Staff Summary Report

Development Review Commission Date: 10/09/07

SUBJECT: Hold a public meeting for a Development Plan Review for CHURCH ON MILL located at 1300 South Mill Avenue.

COMMENTS: Request for **CHURCH ON MILL – CLASSROOM BUILDING (PL070066)** (First Southern Baptist Church of Tempe, owner; Joel Nice, Bardusen Architects, applicant) for a +/-14,600 s.f. classroom and administration building added to an 13,932 s.f. worship and ministry campus on +/- 3.16 acres, located at 1300 S. Mill Avenue, in the R-2, Multi-family Residential District. The request includes the following:

sheet / 01/18/07
 phase / 0100
 project no. /
A3-1
 Elevations

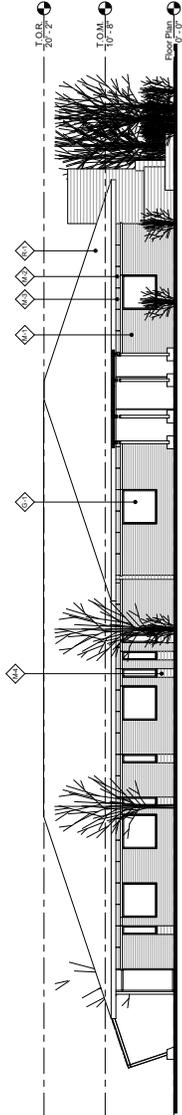
10. **Add a window on the southern end of the east face of the building.**
11. Provide main colors and materials with a light reflectance value of 75 percent or less. Specific colors and materials exhibited on the materials sample board are approved by planning staff. Submit any additions or modifications for review during building plan check process. Planning inspection staff will field verify colors and materials during the construction phase.

CONCEPTUAL PLANTING PLAN

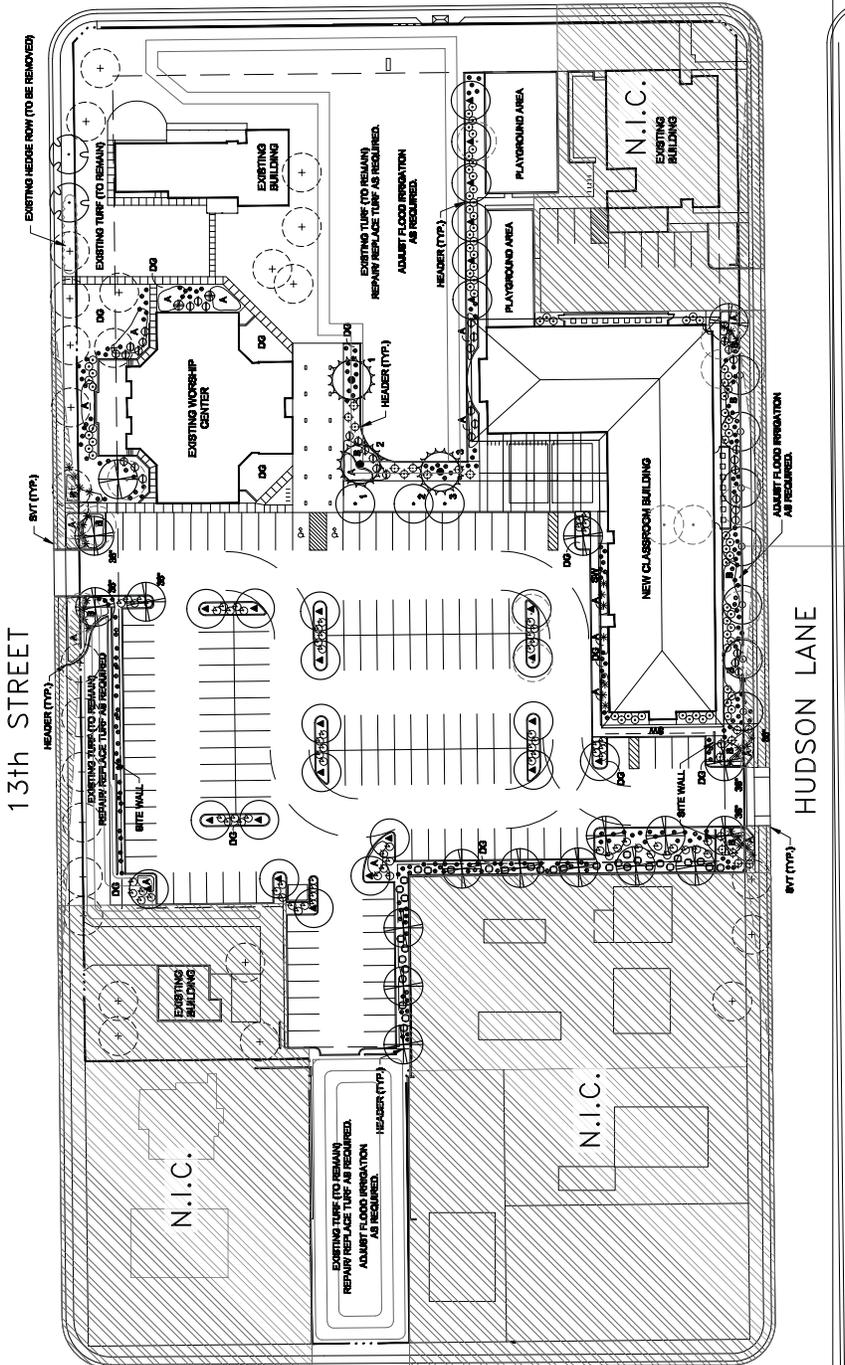
The proposed landscape plan for the project includes approximately 48% landscaped area, with most mature trees remaining and new 24" and 36" box trees added along the western and southern perimeter of the site. The plan **has been revised to provide Mesquite along Hudson, to provide shade and a green canopy tree, Arizona Ash are proposed along the western border adjacent to the single family houses, to provide a year-round green canopy screen. These trees are spaced 30' apart for the western buffer adjacent to single family homes; staff has conditioned that these trees to be spaced 20' apart for more buffering (see Landscape conditions). The western boundary will have an 8' high masonry wall and a 6' landscape buffer up until the northern face of the new classroom building. From the back of sidewalk, north approximately 73 feet 7 parking spaces were removed and a 22' wide landscape buffer with a second row of trees has been added adjacent to the residence to the west.** The existing eucalyptus along Hudson will be removed, and three mature trees will be relocated. Staff has conditioned that as many of the mature native species be retained as possible (see Landscape conditions). New trees proposed include: **AZT Hybrid Mesquite**, Arizona Ash, Evergreen Elm and Chinese Pistache. The combination of trees will provide year round color, and a variety of textural interest. New shrubs proposed include Texas Ranger and Rio Bravo sages, Valentine Bush, Nashville Grass, Baja Ruellia, Red Yucca and Mexican Bird of Paradise. Ground covers include Turpentine Bush, Gold Lantana and Trailing Rosemary, along with decomposed granite and existing large flood irrigated turf areas to remain. The parking lot area is improved with the addition of shade trees and planter islands. The landscape plan is sensitive to the existing lush flood irrigated character of the area, but with an updated, more drought tolerant palette on the portions

- Retain as many mature trees as possible, salvage and relocate native species where possible. Replace removed trees with new.
 - Provide street trees a minimum of one tree every thirty lineal feet of street frontage.

- Provide one tree every twenty lineal feet of perimeter of the property where adjacent to residential uses (western property line and/or at the perimeter of the parking lot).
- Indicate the location of all exterior light fixtures on the site, landscape (and photometric) plans. Avoid conflicts with lights in order to maintain illumination levels for exterior lighting.
